Amendments to the Drawings

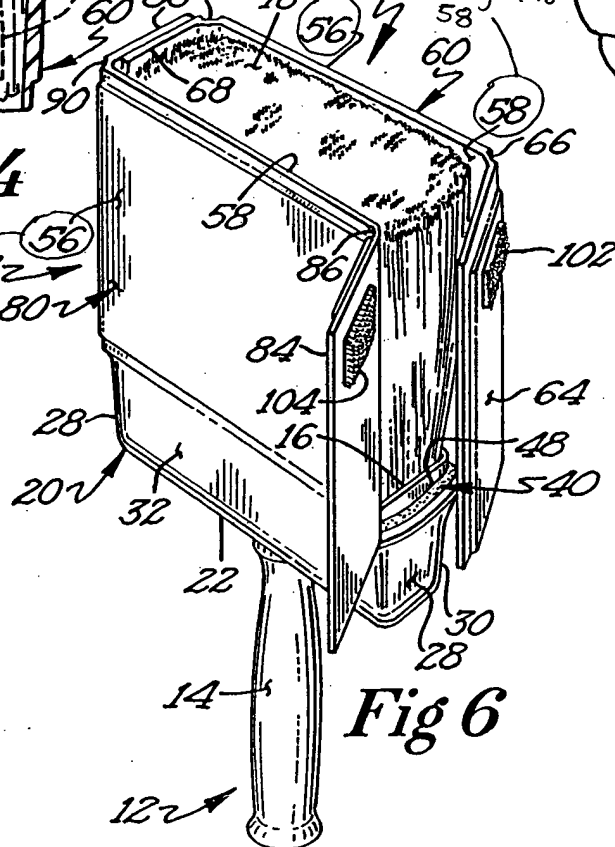
The attached sheets of drawings include changes to Figure 2 and 3, and Figures 4, 5, and 6. The first sheet, which includes Figures 2 and 3, replaces the original sheet including Figures 1-3. In figure 2, a portion of the left panel sleeve have been removed to show the inner liner 40 as it nests within the sleeve 20; note elements 42, 44, 24, and 30. Elements 56 and 22 have been added, and one of the two sidewalls has been changed from 28 to 26. In Figure 3, previously omitted element 42 has been added.

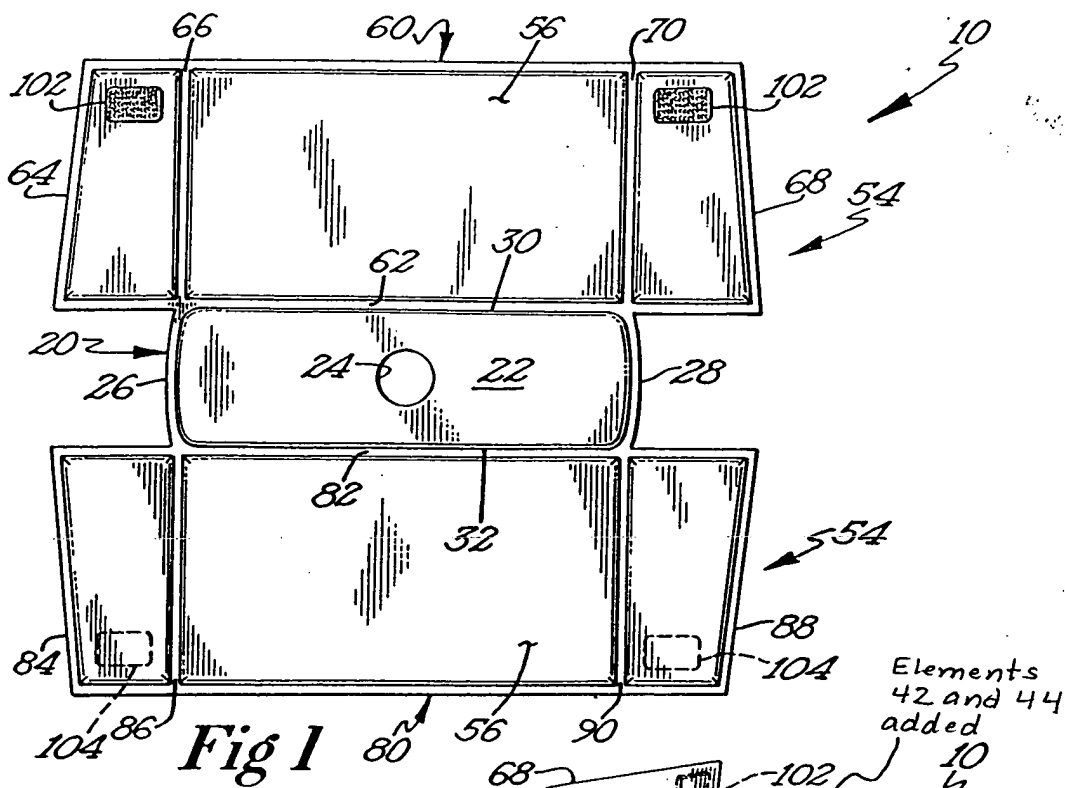
The second sheet, which includes Figures 4, 5, and 6, replaces the original sheet including Figures 4-6. In Figure 4, previously omitted element 42 has been added. In Figures 5 and 6, element 56 has been renumbered to 58, while element 58 has been renumbered to 56, so that they comport with numbers 56 and 58 in the other figures.

Fig 3

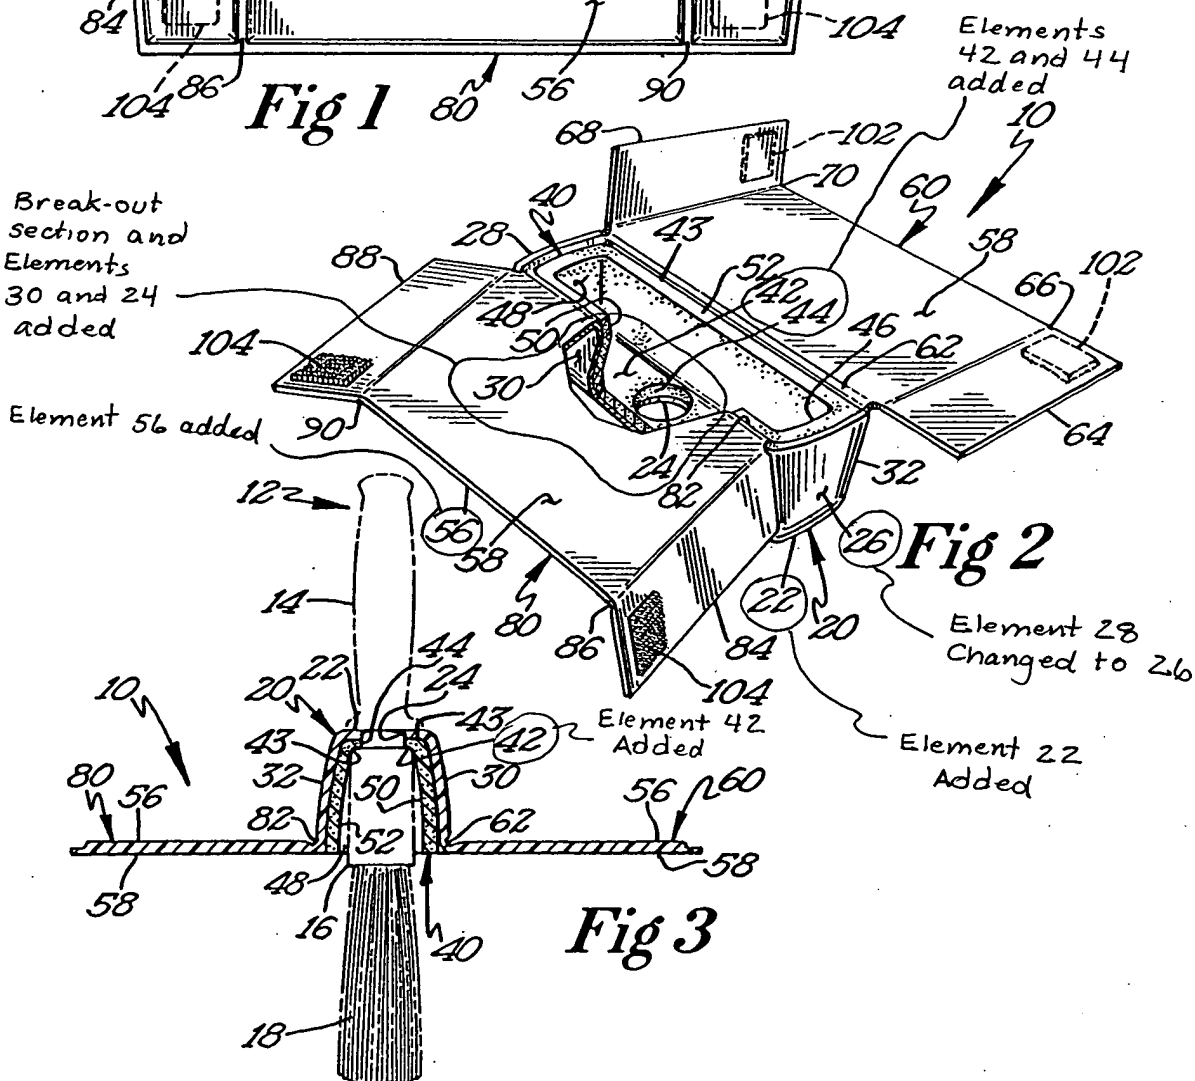
Element 58 Changed to 56

Break-out
 section and
 Elements
 30 and 24
 added

Element 56 added

Elements
 42 and 44
 added

Element 28
 Changed to 26

Element 22
 Added

Element 42
 Added
